Keep Safety on Your Side

“Better safe than sorry” is a good idea when dealing with vehicles from the M113-series family.

Ramp Access Door

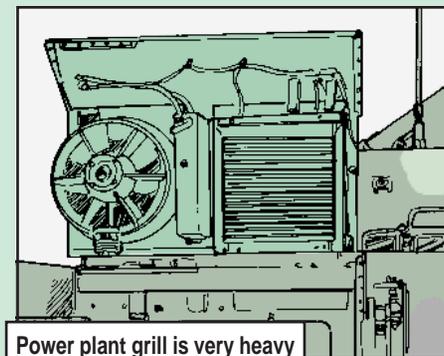
Most soldiers use their left hand to close the ramp access door when inside the vehicle. Unfortunately, that exposes their left thumb to danger.

If the thumb is extended, it may stick out far enough to get caught between the door and the door frame.

So, add the following WARNING to Page 2-142 of TM 9-2350-261-10 and Page 2-159 of TM 9-2350-277-10:

WARNING

Use of the left hand to grasp and close the ramp access door will expose thumb to being extended beyond the door’s edge leading to possible amputation when the door is pulled closed. When using left hand, use only the center of the handhold and be aware of the thumb’s position.
